A-580178

1712 B TELEPHONE SET CONNECTING DIAGRAM

WESTERN ELECTRIC CO. INC. ENGINEER OF MANUFACTURE

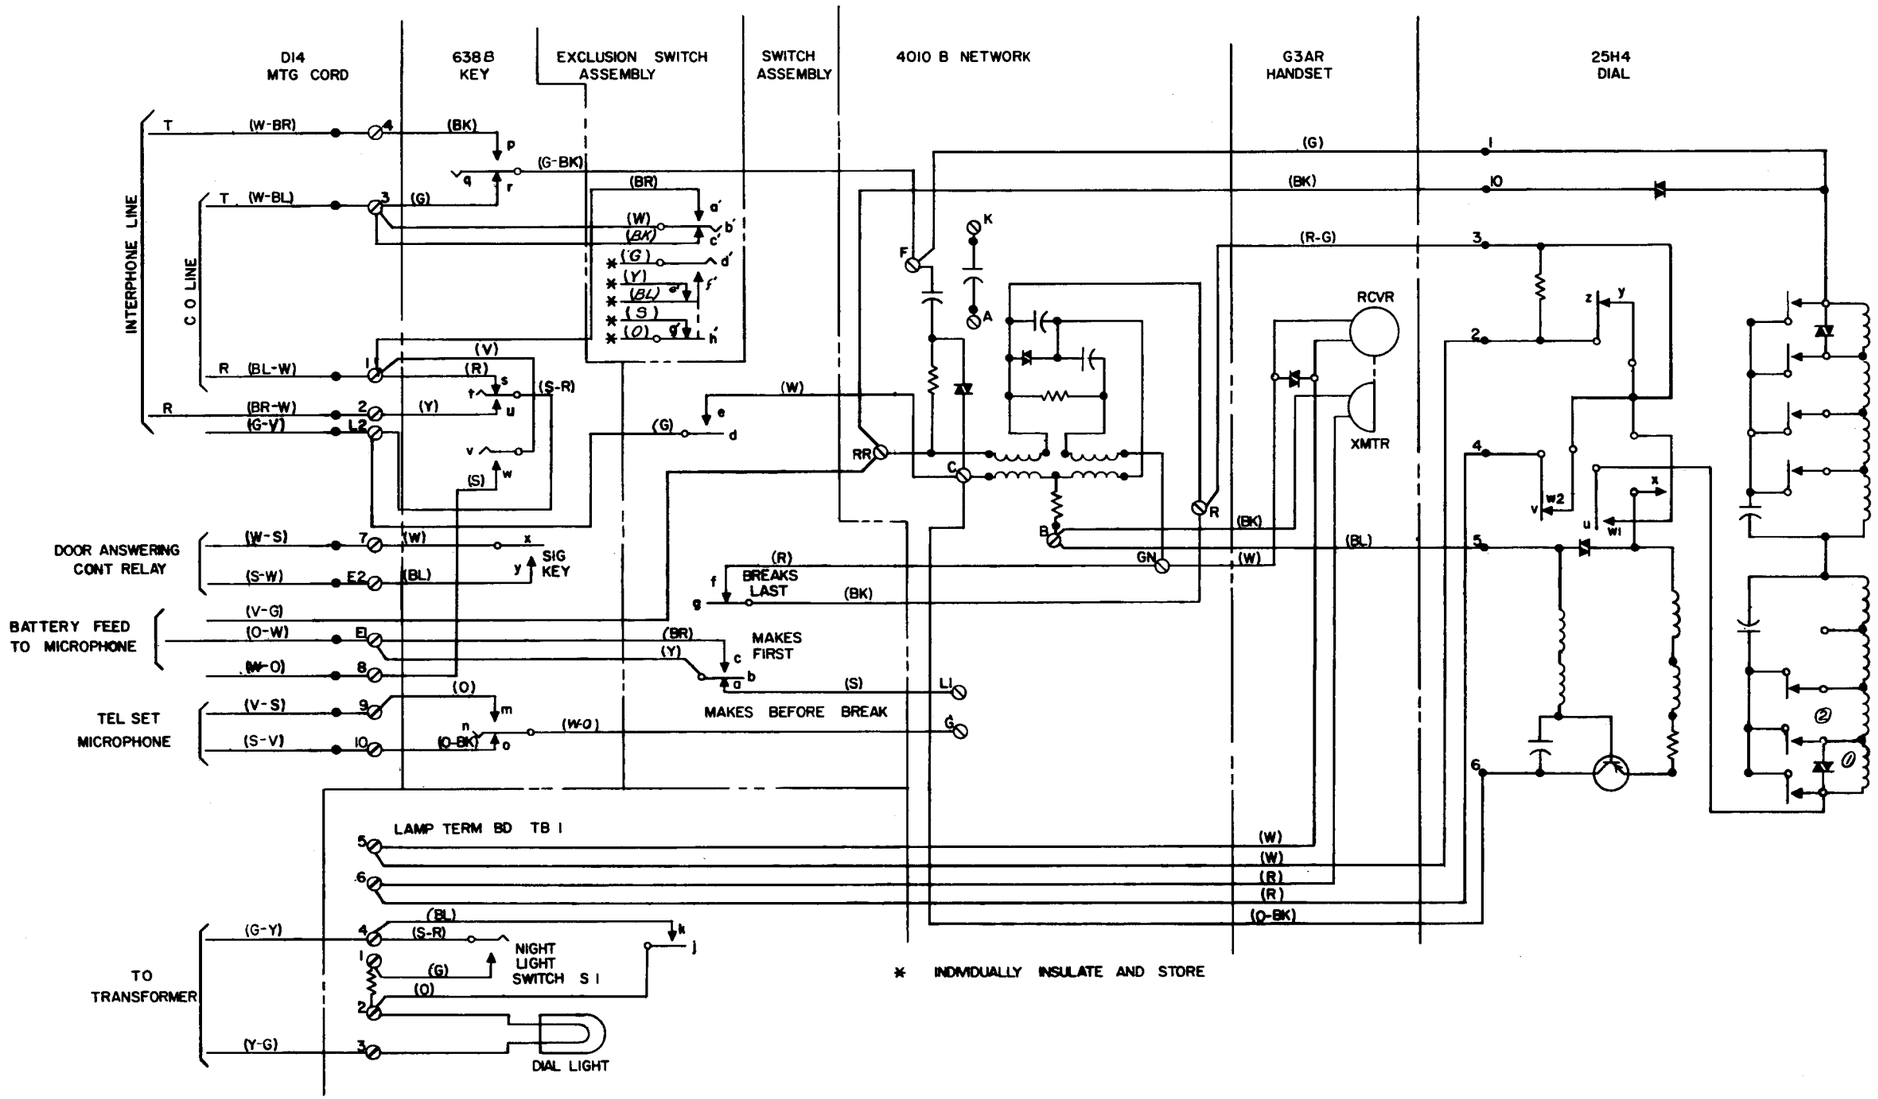
CHANGED: TO AGREE WITH ISS.3, P-24E201, & ISS.4, P-24E225.

CHANGED: 638B PORTION WAS 638A; LEAD TO G TERM OF 4010 B NET. WAS O-W

CHANGED: IN EXCLUSION SW ASSEM, COLORS FOR LEADS 6' THRU 6' WERE RESP O, Y, BL, O, R, G-Y, W; CONTACTS e' & f' WERE REVERSED.

CHANGED: COLOR OF (17) LEAD FROM TERM 2 OF LAMP TERM BD WAS (O-W); COLOR OF (17), (BR), (R), & (W) LEADS FROM SW ASSEM WERE RESP (S-Y), (S-BR), (S-R), & (S-W). VARISTOR AT ⓪ OF 25H4 DIAL WAS AT ⓪
